Re: Turkey Point Units 3 and 4
Docket Nos. 50-250 and 50-251
Response to NRC Request for Additional Information Regarding
License Amendment Request No. 217 – Administrative Changes to
Operating License Conditions and Technical Specifications

**Response to NRC Request for Additional Information Regarding
License Amendment Request No. 217 - Administrative Changes to
Operating License Conditions and Technical Specifications**

Response to Request for Additional Information

FIGURE 1

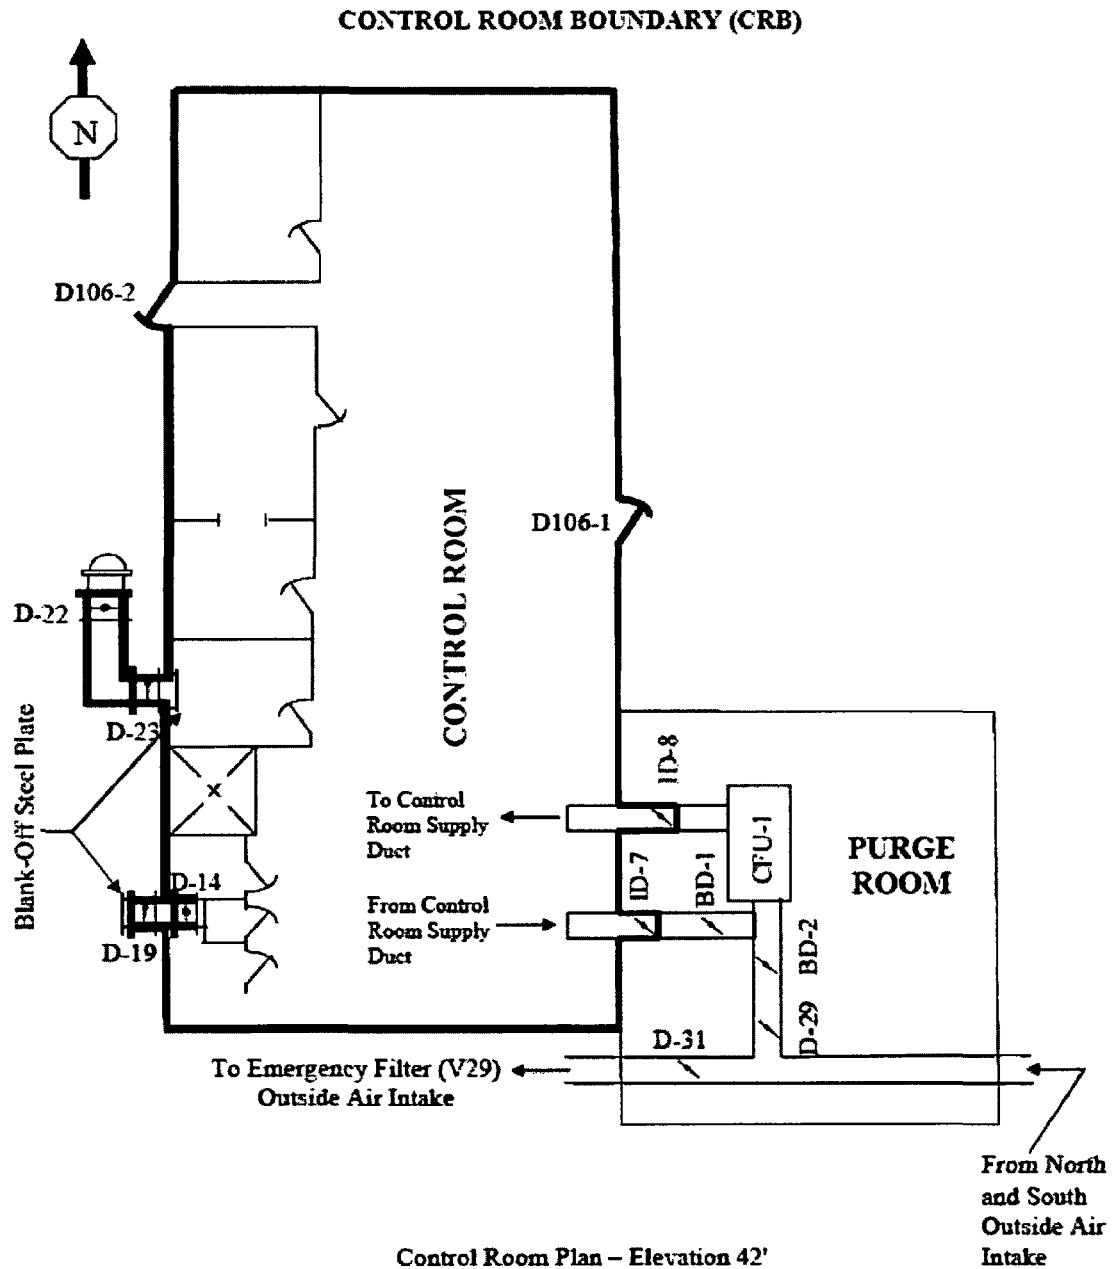
SCVB-1 In the September 14, 2012 submittal, the licensee states that condition 3.I.(a) and (c) were satisfied with completion of the tracer gas testing and pressurization testing on July 25, 2012—no results are provided from the test. Please provide the test results and discuss how the Control Room test configuration is consistent with the AST assumptions.

As a result of these actions, the CRE was tested with the exhaust ducts blanked off (See Figure 1 - CR Plan - Elev. 42 ft) and one of the two in-series normal air intake dampers (D-1A) failed open (See Figure 2 - CR Plan - Elev. 30 ft) as the worst single failure for the unfiltered inleakage and pressurization testing of both normal and compensatory filter trains. The measured unfiltered CRE inleakage and differential pressure results are as stated above for both the normal and compensatory filter trains. Figures 1 and 2 showing Control Room Boundary (CRB) plan views and applicable isolation dampers are attached.
